BIGGS & MATHEWS ENVIRONMENTAL

June 27, 2014

Re: 130 Environmental Park – Caldwell County
Municipal Solid Waste (MSW) – Permit No. 2383
Response to Second NOD for Land Use Compatibility Determination and
Submittal of Complete Parts I, II, III, and IV Permit Application
Tracking No. 17458939 (17937410, 17978232, 17992596, 18005911);
CN604375972/RN106897036

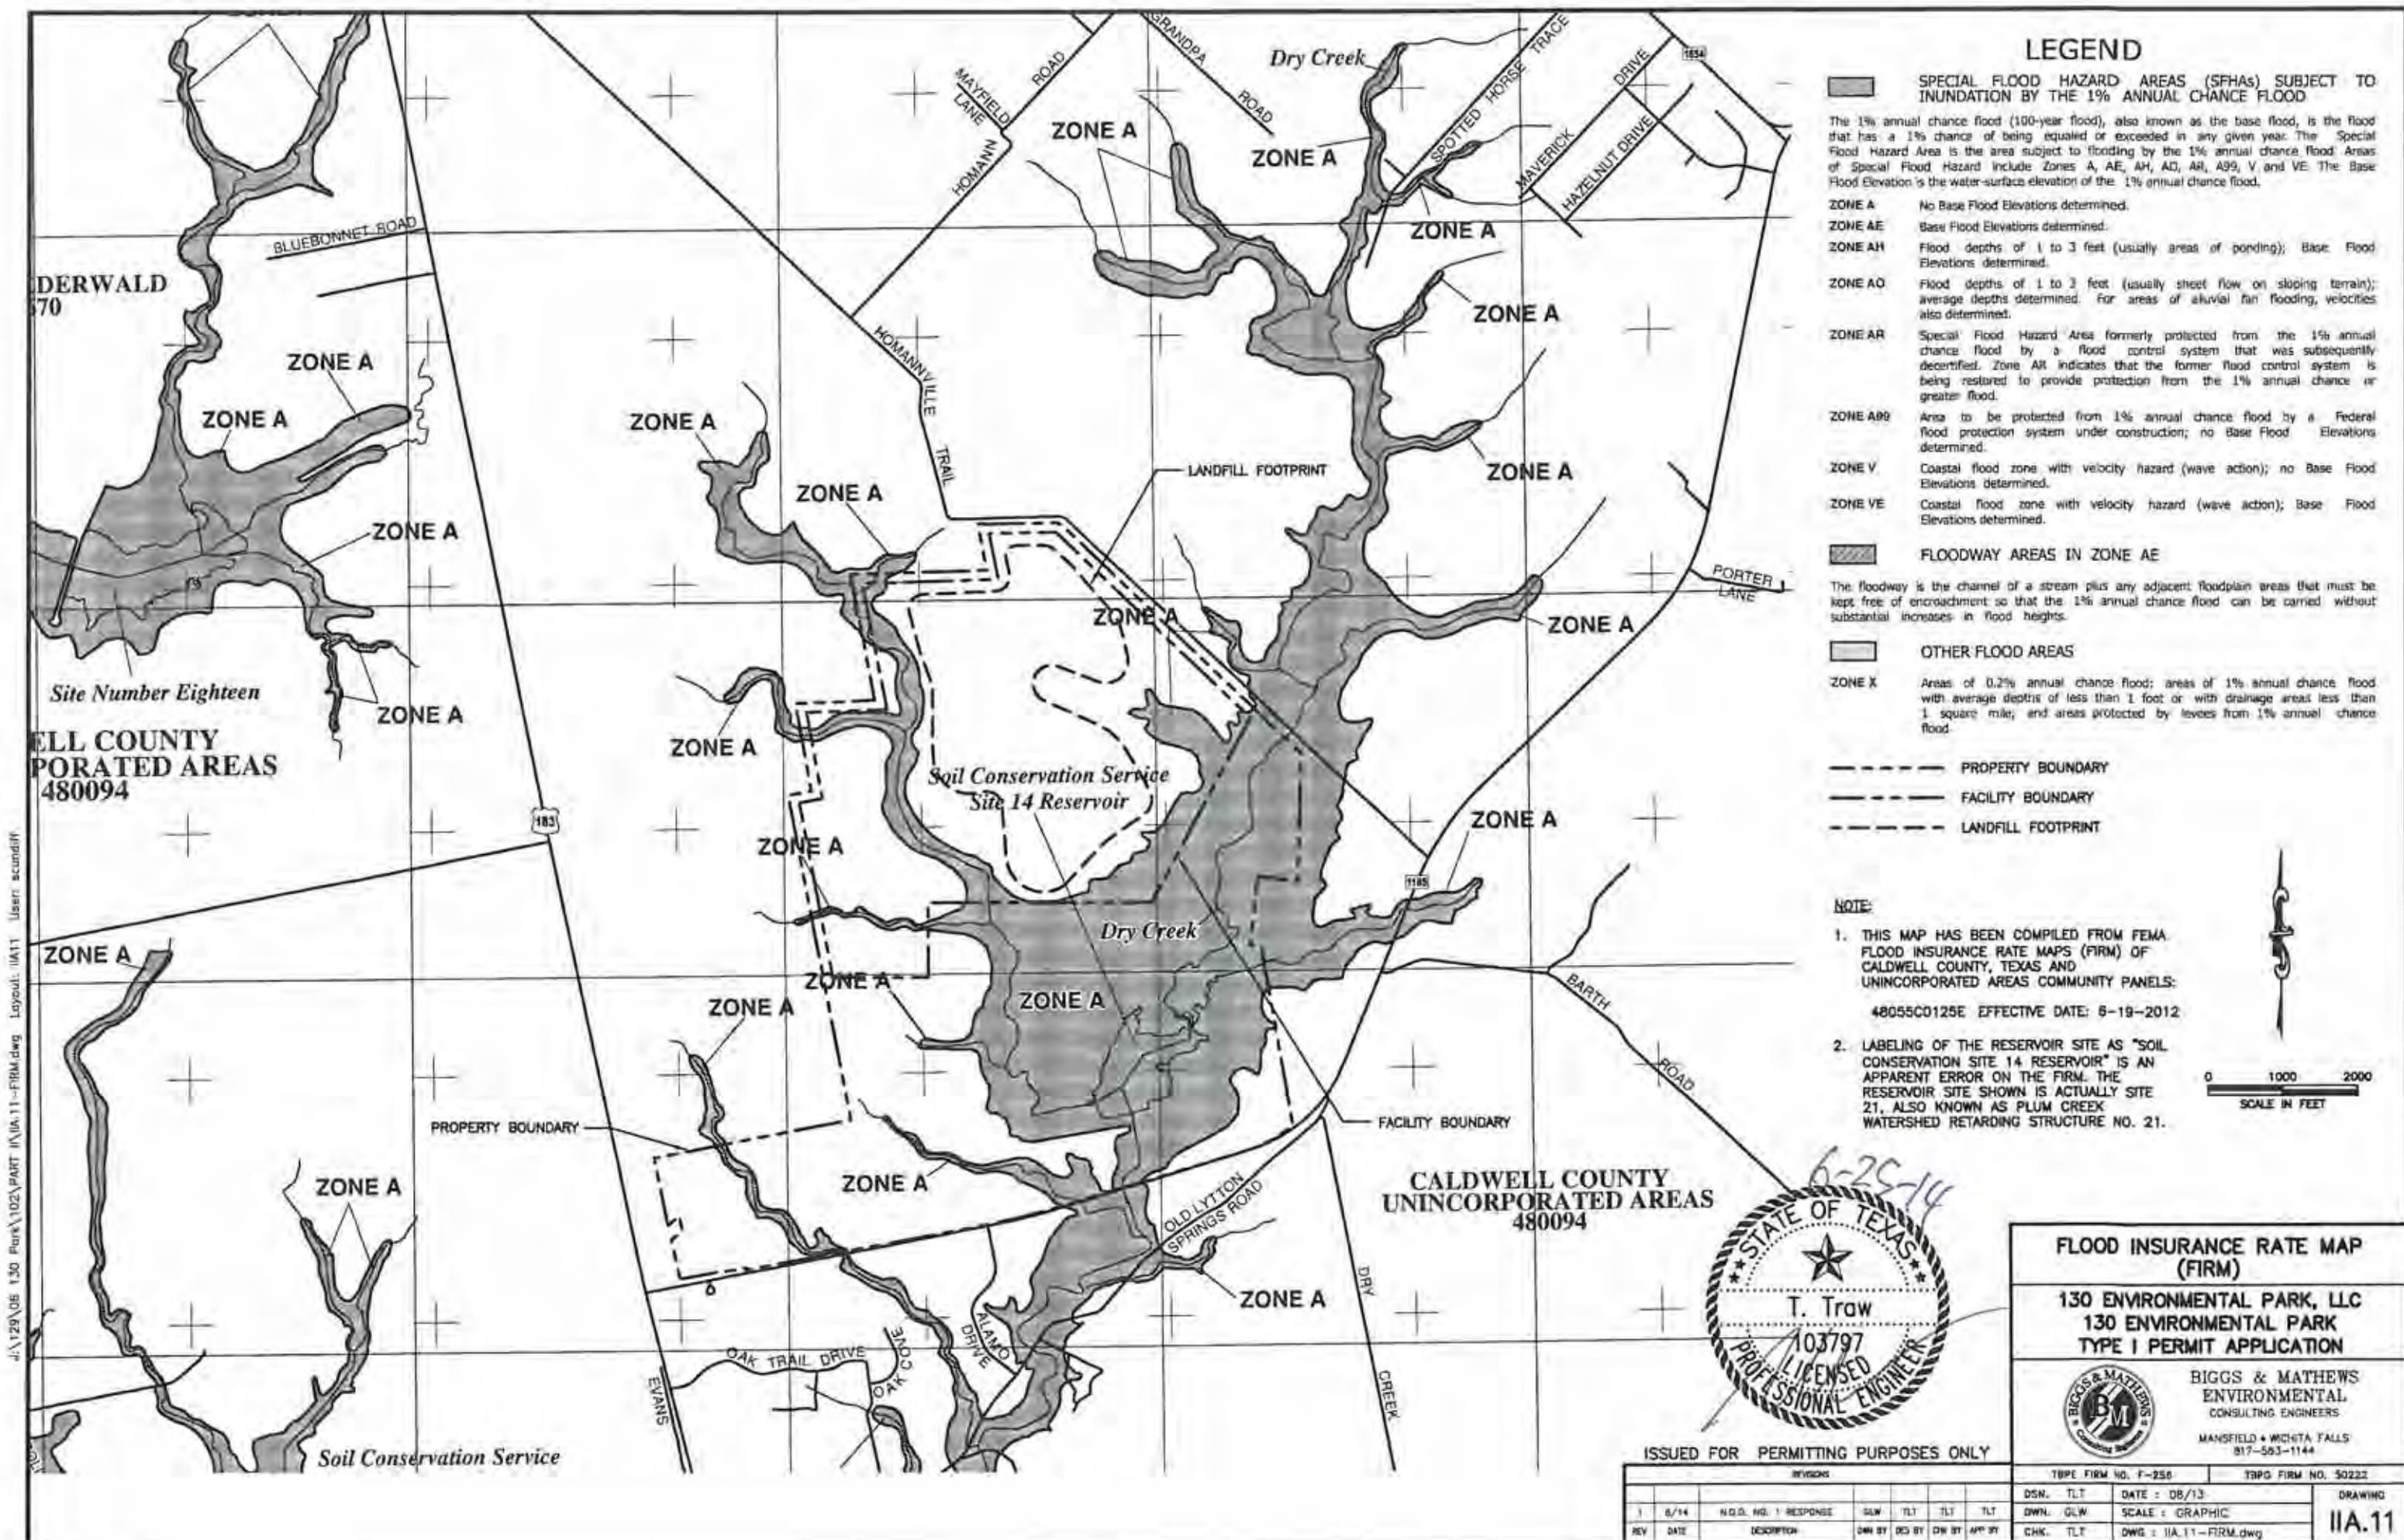
- Attachment C2-A-1 and Part II, Drawing A.11, have been revised by leaving the original label "Soil Conservation Service Site 14 Reservoir" on the FEMA FIRM and adding a note that the label is an apparent error and should be "Soil Conservation Service Site 21 Reservoir".

REVISIONS						TBPS FIRM NO. F-256		TBPS FIRM NO. 50222		DRAWING IIA.13
REV	DATE	DESCRIPTION	DES BY	DES BY	APP BY	DSN. K.J.W.	DATE: 8/13	DWN. G.L.W.	SCALE: GRAPHIC	
1	1/14	NO. 1 RESPONSE	GLW	NDM	NDM	CHK. K.J.W.	DWG: IIA.13-SiteLay.dwg

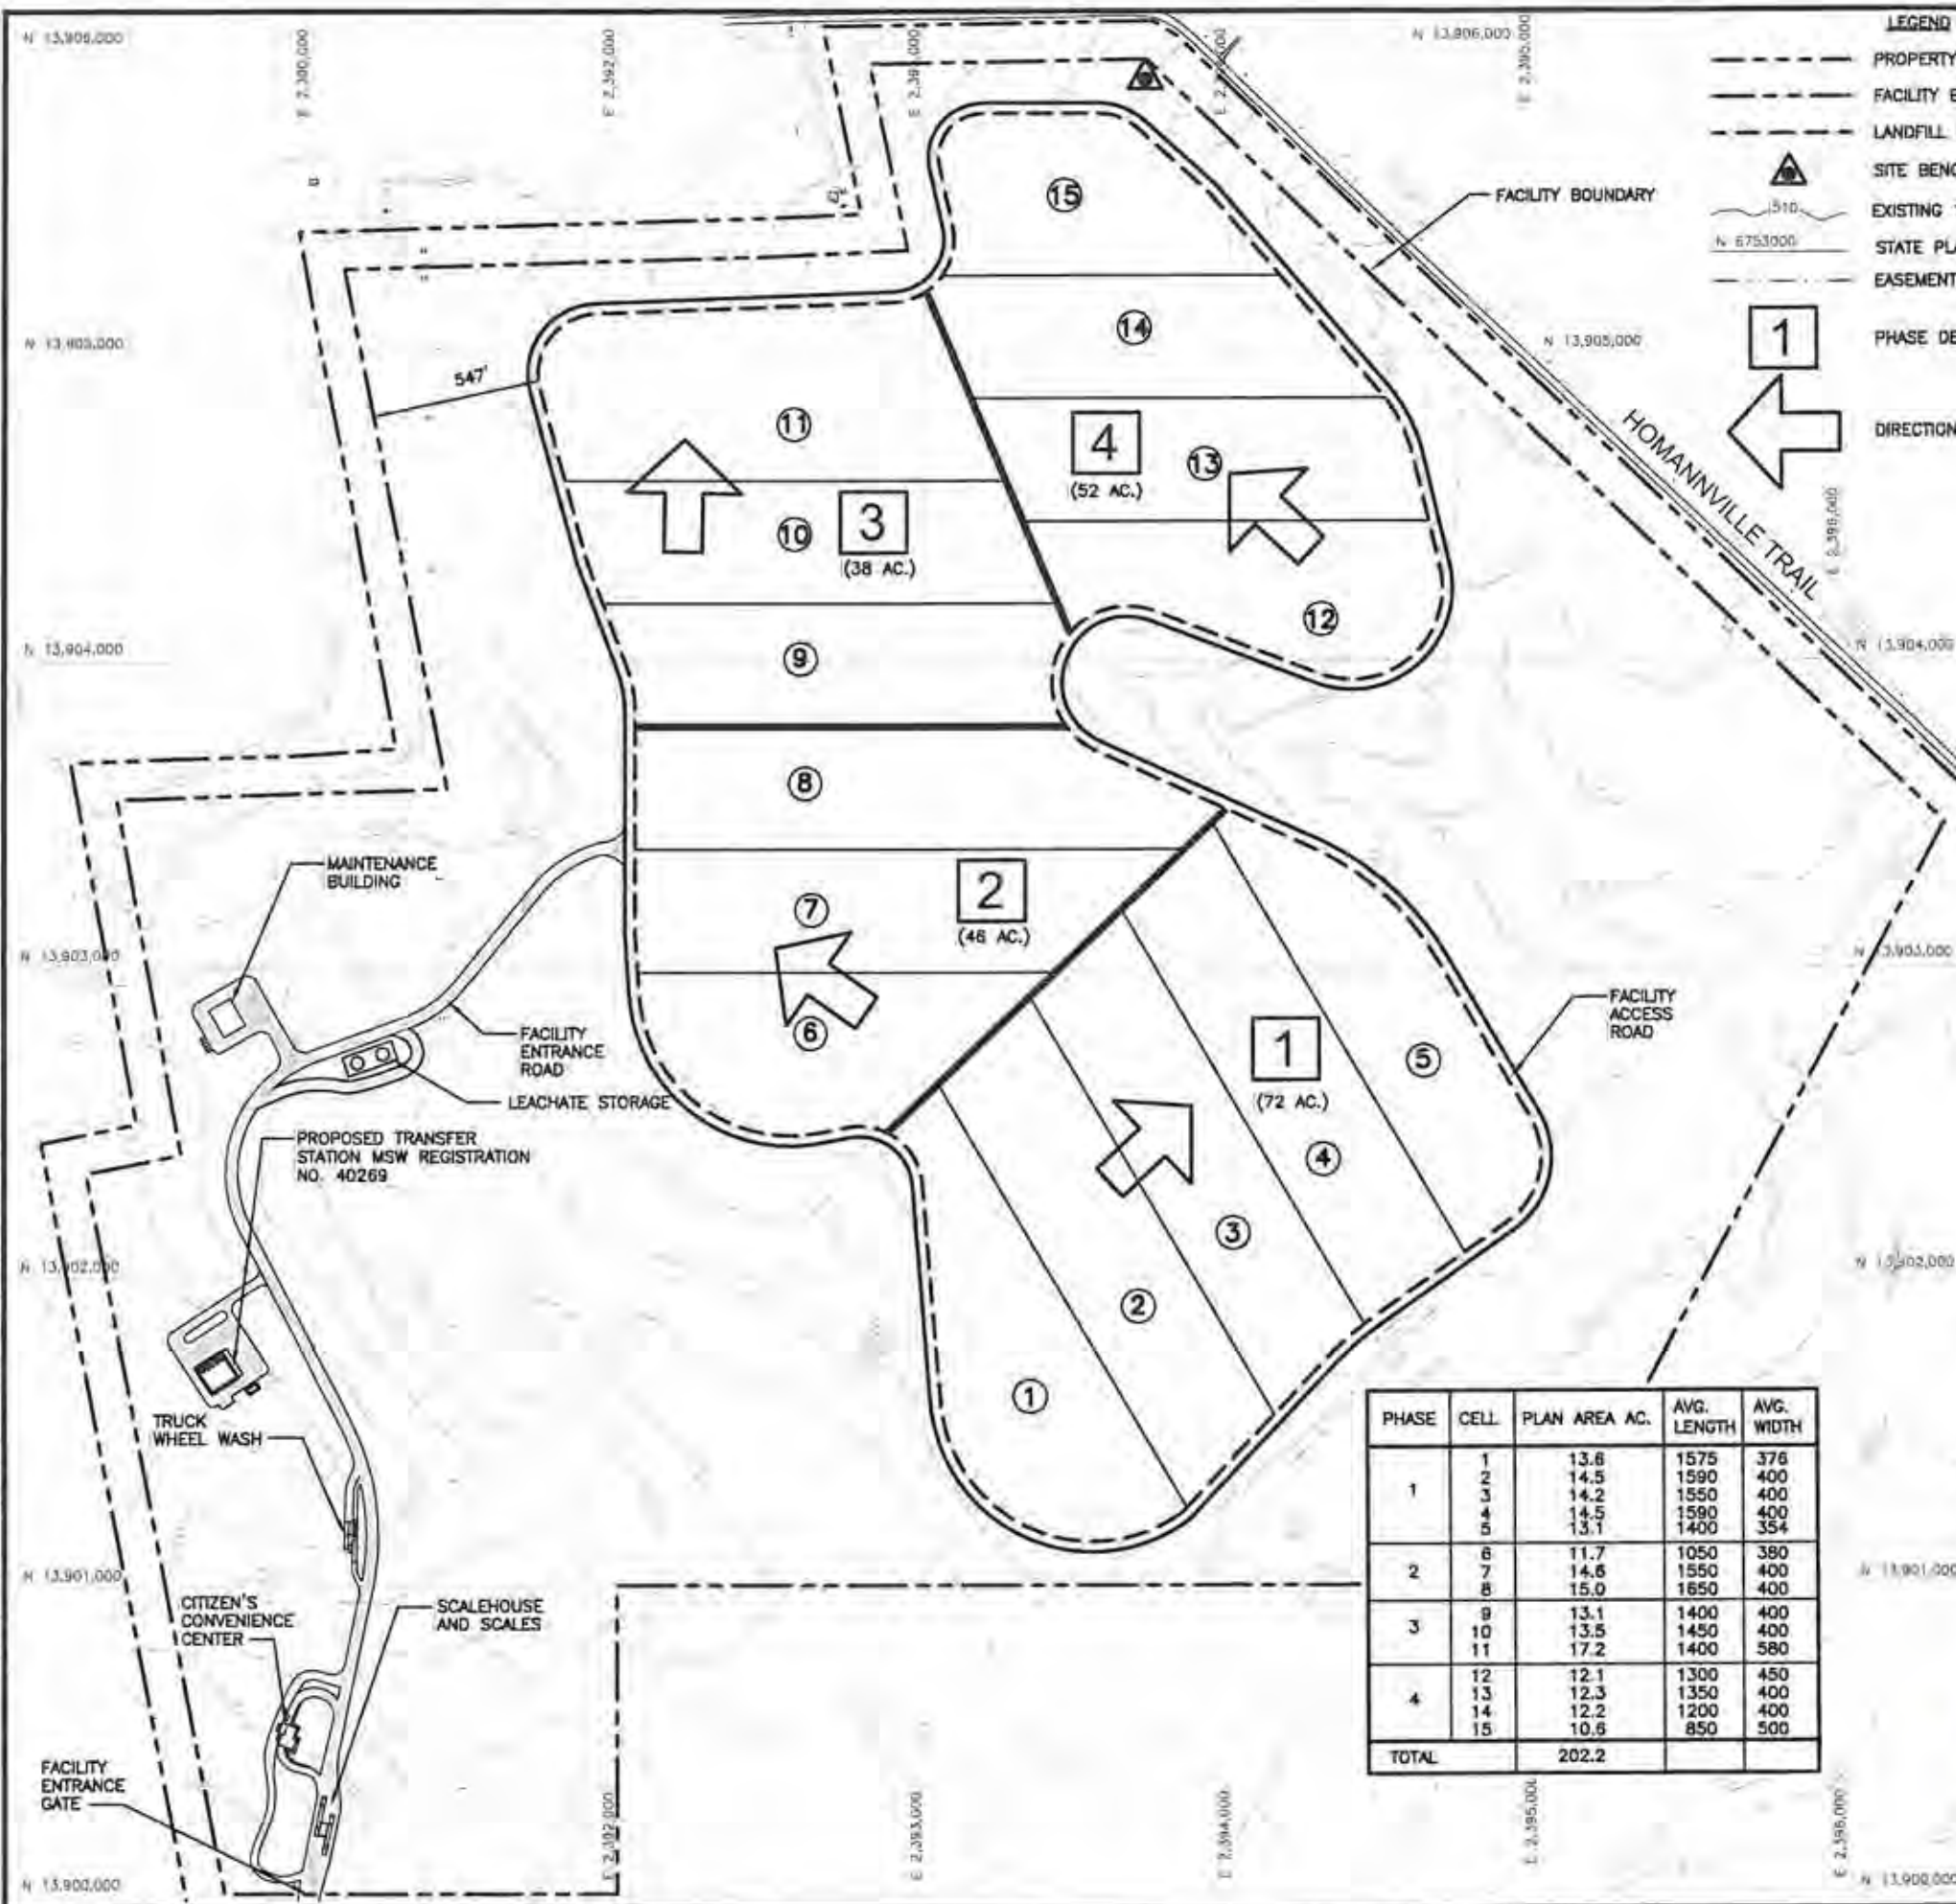
1. Comment 8 of the first NOD requested that, in accordance with 30 TAC §330.61(b)(1), the Waste Acceptance Plan (WAP) include a description of the materials to be stored or processed. The submittal now provides this information in Part II, Section 2.1. While several of these storage and processing areas were identified on Drawing IIA.13, some could not be located on a site layout figure. Please be certain that all storage and processing areas are identified on a facility layout figure.

RESPONSE: *The locations of the additional material storage and processing areas were identified in Attachment B, Drawing B.2, Notes 3 through 6, in the previous submittal. The notes have been added to Drawing IIA.13 in this submittal.*
